**ATTACHMENT A
PLANNING AND ZONING COMMISSION RESOLUTION NO. 2009-047**

HILLSIDE DISTRICT PLAN

(CASE NO. 2009-090)

As Approved by the Planning and Zoning Commission

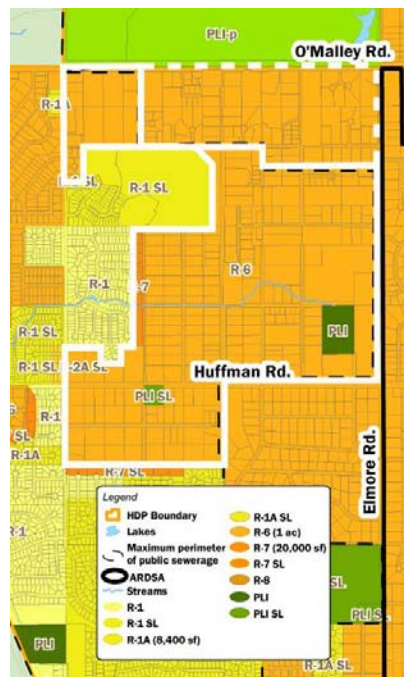
28. Page 2-28 Map 2.10 (Issue LU-6) Modify Map 2.10 and associated text to be consistent with the above language and intent as shown in the table below, i.e., change 2 dua with an 8-acre parcel or 3 dua with 12-acre parcel and change 10 to 12 acres.

Remove highlight of BLM lots and remove the following language: ~~Possible area for future increased residential density; expected to be re-examined when the Hillside District Plan is updated.~~

Change map in Furrow Creek area to reflect the modified boundary below:

29. Page 2-29 Figure 2.11. Modify Figure 2.11 to be consistent with above language and intent under Background and as reflected in the above table.
30. Pages 2-5. and 2-32 (Issue LU-26k): Revise Goal 3 to read: “Plan land use, transportation infrastructure, and other infrastructure to serve anticipated growth to be efficient in terms of public expense, energy use, and other resources.”
31. Page 2-33 Goal 4, (ASD comments) Background “Schools” heading: Delete wording under this heading and replace with the following text:
